RE: Rail Loadout Updates, Clean Copies Task ID 4968, Canyon Fuel Company, LLC, Skyline Mine, C/007/0005,

**Title:** Rail Loadout Updates

Addition of pavement, concrete, silt trap to Rail Loadout – Clean Copies ID 4968

**LOADOUT FACILITIES DRAINAGE AND PERMIT BOUNDARY MAP**  
No. 8156171 2200  
MASON DALE ENGINEERING  
Canyon Fuel Company, LLC  
Skyline Mines

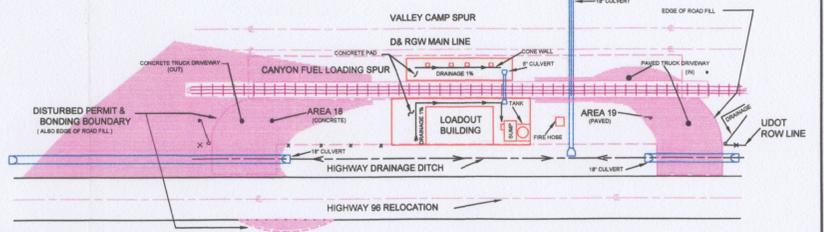
Attached to this letter is pertinent information addressing modifications to the Skyline Mine M&RP to include minor improvements and maintenance items to the site. Concrete will replace asphalt west of the silos, the entrance and exit east of SR-96 will be widened, and a cement silt trap will be added to disturbed ditch DD-11 to reduce the sediment load to the sediment pond. No topsoil or subsoil needs to be relocated in these activities. Slight modifications to the bond pages were made based on Ms. Cheryl Parker's request.

With an increase in truck traffic beginning in approximately 2009, the truck loop around the storage silos accessed from SR-96 was upgraded from gravel to asphalt to help control both dust and track-out. In 2015, areas of high traffic where asphalt deteriorated quickly were replaced with concrete. In addition, while high maintenance areas were being upgraded with concrete (approximately 123 cy), the entrances were widened to address problematic safety issues involving the turning radius and view corridors for the coal trucks exiting and entering SR-96. Sediment control for all disturbed areas within the Rail Loadout site report to the sediment pond via sheet-flow or ditches, with the exception of Alternate Sediment Control Areas (ASCAs) and Small Area Exemptions (SAEs) identified on Plate 3.2.1-3 and discussed in Section 3.2.12. The areas accessing SR-96 are considered Small Area Exemptions (SAEs) because they are part of the permit area not reporting to the sediment pond. Areas 18-22a were enlarged in 2015 (see Section 3.2.12 pages 3-69 through 3-71). Existing culverts in Areas 21 and 22 conveying SR-96 runoff were extended to accommodate the increased area of ditch covered with the expansion.

**Areas 20, 21, 22 AND 22a.** These areas are the highway approaches from SR-96 to the Railroad Loadout area itself (two approaches), and the area south of the loadout structure. These areas are shown on Map 3.2.1-3. Areas 21 and 22 also encompass areas 18 and 19. Areas 21/19 and 22/22a/18 contain approximately 0.1 acres and 0.20 acres, respectively and have been classified as "Special Exempt Areas." Road approach 21/19, and 22a are paved with asphalt while 22/18 -are paved with concrete to handle loaded trucks. Area 20 also contains a small straw dike to treat water from the area that is not paved and additional treatment for water leaving the paved area. All of these areas are part of the permitted area and will be reclaimed during final reclamation; however, these areas fall within the rights-of-way of SR-96 (refer to UDOT letter dated 7-18-89 from L. Archie Hamilton, District Four Pre/Construction Engineer, found in this section). The Permittee has no control over the activities of UDOT or the public who utilize these approaches; therefore, the Permittee is not responsible for the activities (other than his own) which occur on these approaches. In 2015 Areas 21 and 22 increased in size to accommodate increased truck traffic; both to accommodate the turning radius of larger trucks and to have a better field of view leaving the site.
